City of Portland, Maine - Building or Use Permit Application

Permit No: 03-0313	Issue Date: APR 17 2003	CBL: 087 I002001
-----------------------	-----------------------------------	---------------------

Proposed Project Description: Building 18' x 31' addition, 9' x 24' gallery and 17' x 24' deck.	Signature:	Signature: JMB 4/17/03
PEDESTRIAN ACTIVITIES DISTRICT (P.A.D.)		
Action: <input type="checkbox"/> Approved <input type="checkbox"/> Approved w/Conditions <input type="checkbox"/> Denied		
Signature:	Date:

Project: Moxhey Residence-Easterling
100 Pleasant Ave.
Potsdam, Maine

○ SECOND FLOOR PLAN

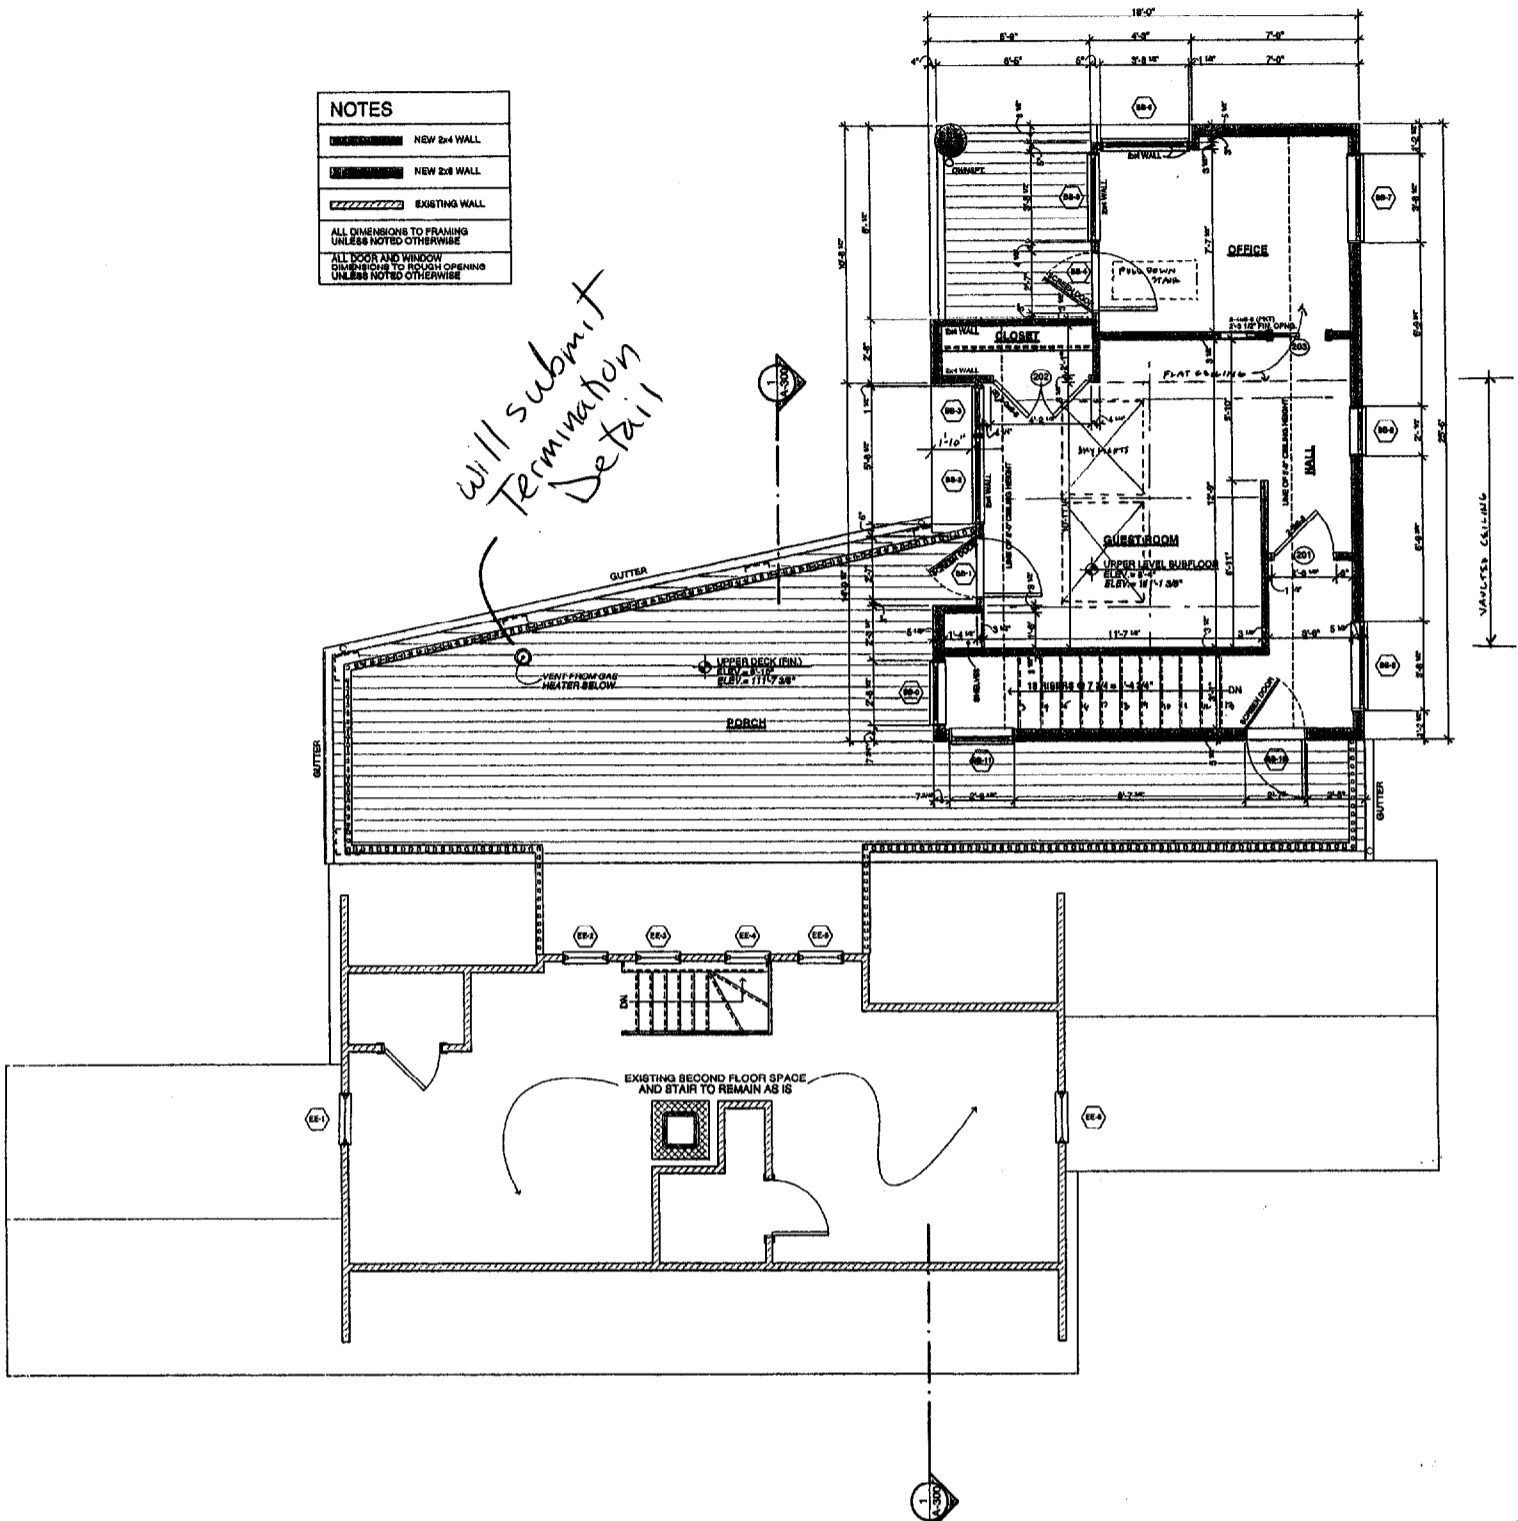
- 1) Guardrails will be needed per BOCA 1999 if more than 15-1/2" change of grade.
- 2) Detailed specifications must be submitted for the vent termination of the gas stove as it will exit on the 2nd floor deck.
- 3) Separate permits are required for any electrical or plumbing work.

will submit Termination Detail
